# Non Material Amendment Statement

**BRIAN  
O'REILLY  
ARCHITECTS**

## 98 HIGHGATE WEST HILL LONDON N6 6NR

*FIG. 1 & 2 showing photos received from number 97*

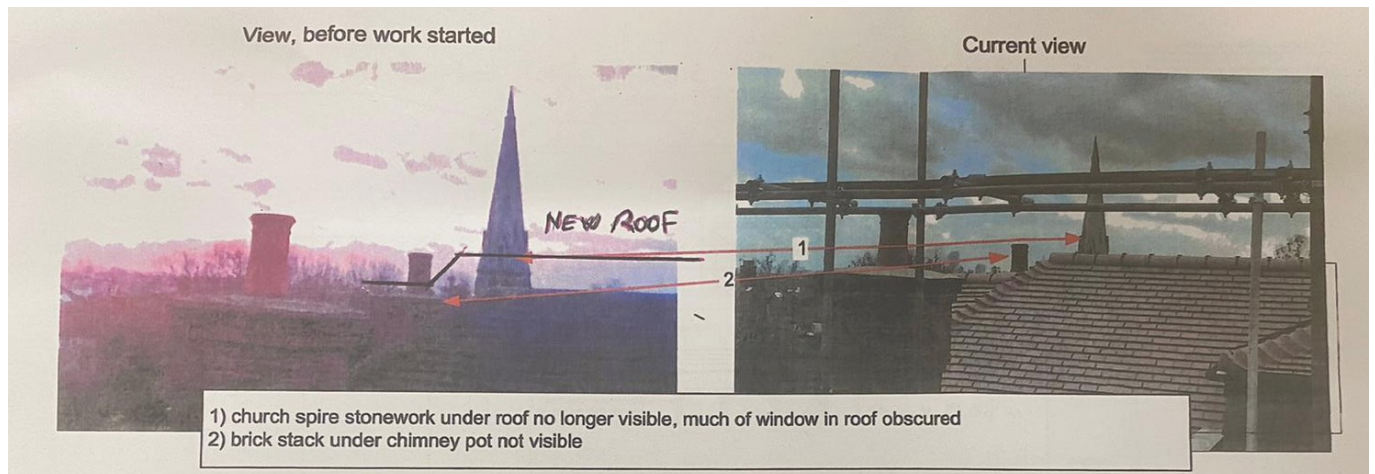
The photographs presented by the number 97 show the roof from 2 different perspectives. Their photos are misleading and this is evident by the relative position of the constant items (Chimney pots & spike). — *SEE FIG. 1 & 2*

*FIG. 3 photo montage showing overlay for direct comparison*

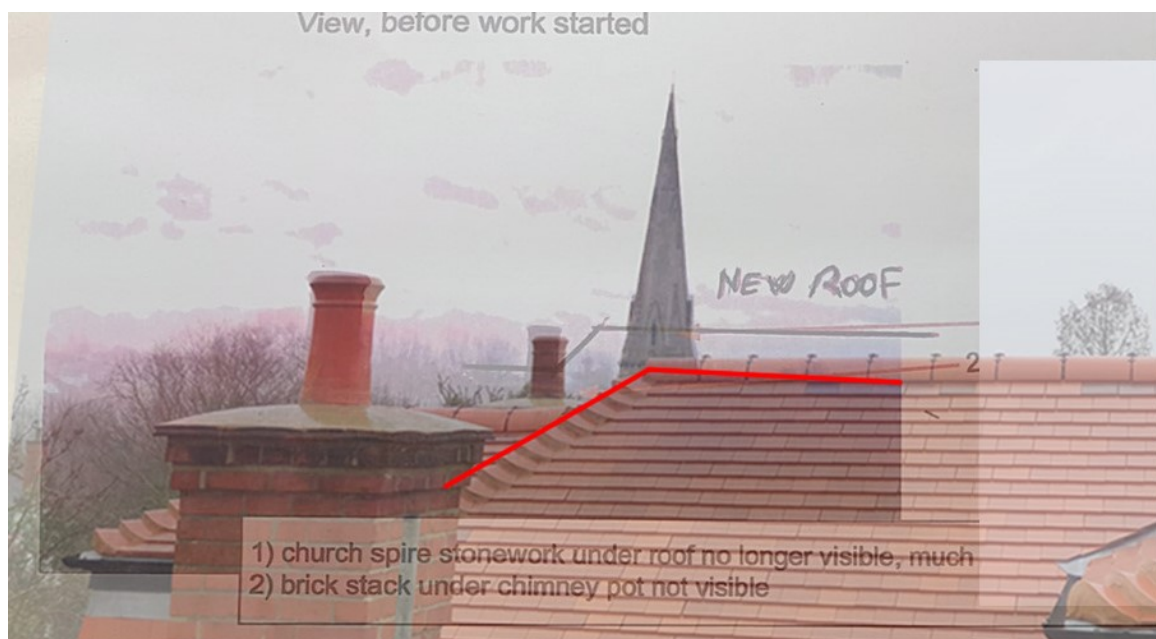
Our superimposed image proves that their perspective assumptions are wrong — *SEE FIG. 3*

FIG. 4 house survey from 2013 showing height of upper ridge is unchanged

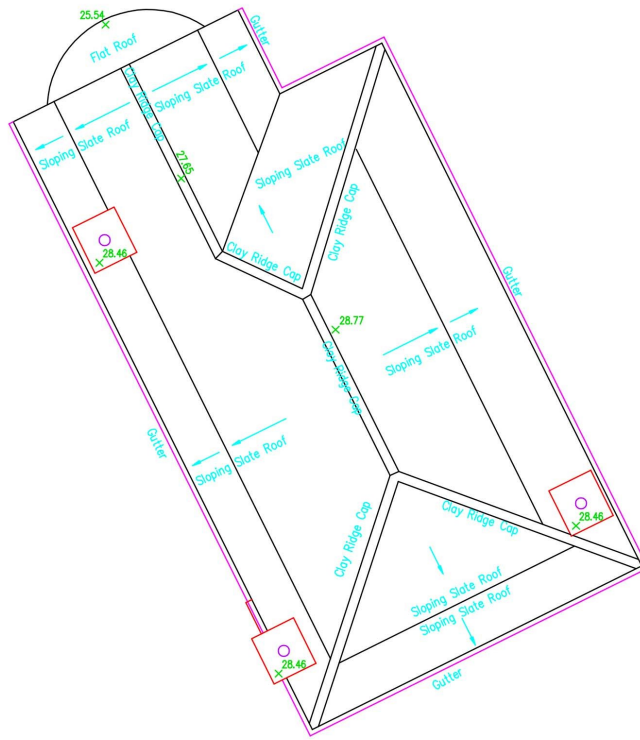
In addition- our clients professional measured survey from 2013 shows spot levels including ridge levels. The upper ridge level is unchanged as built — *SEE FIG. 4*

FIG. 5 street roof scape survey Feb 2020 showing relative ridge

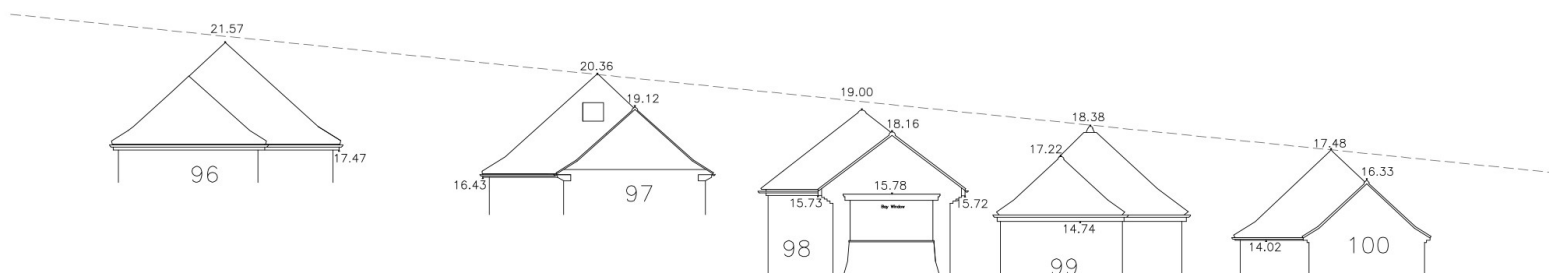
Moreover another professional survey has been carried out in February 2020 after the works to the roof have finished, comparing the heights of the ridges from houses no. 96 to no. 100. The result is that the height of the ridge at no. 98 is under the average height of the ridges of the surveyed area. — *SEE FIG. 5*
